Unibilt Valve/Cylinder Package

Improved design increases reliability and reduces maintenance

Bulletin #8092

Cutaway of a Single Solenoid

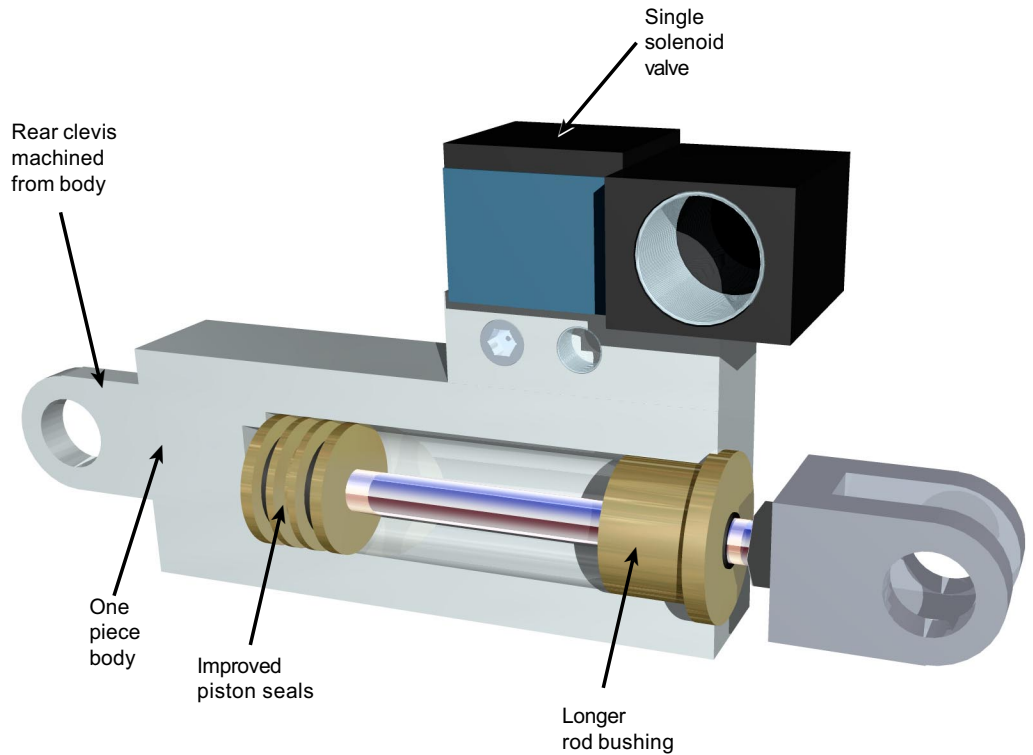
The one-piece body reduces the total number of parts by 50%.

Rear clevis mount is machined from the body, eliminating the rear clevis bolts that were prone to vibrating loose.

Improved piston seals and grease reservoir extends life and provides improved synthetic oil compatibility.

50% longer rod bushing handles more side load, providing increased cylinder life.

Improved package is 100% dimensionally interchangeable with our current package.

The improved package uses the same valve as the current package

OLD PART NUMBER	NEW PART NUMBER	PACKAGE DESCRIPTION
V16995WS	V27791WS	2" Stroke w/ Single Solenoid - Stop
V20173WS	V27790WS	2" Stroke w/ Double Solenoid - Switch
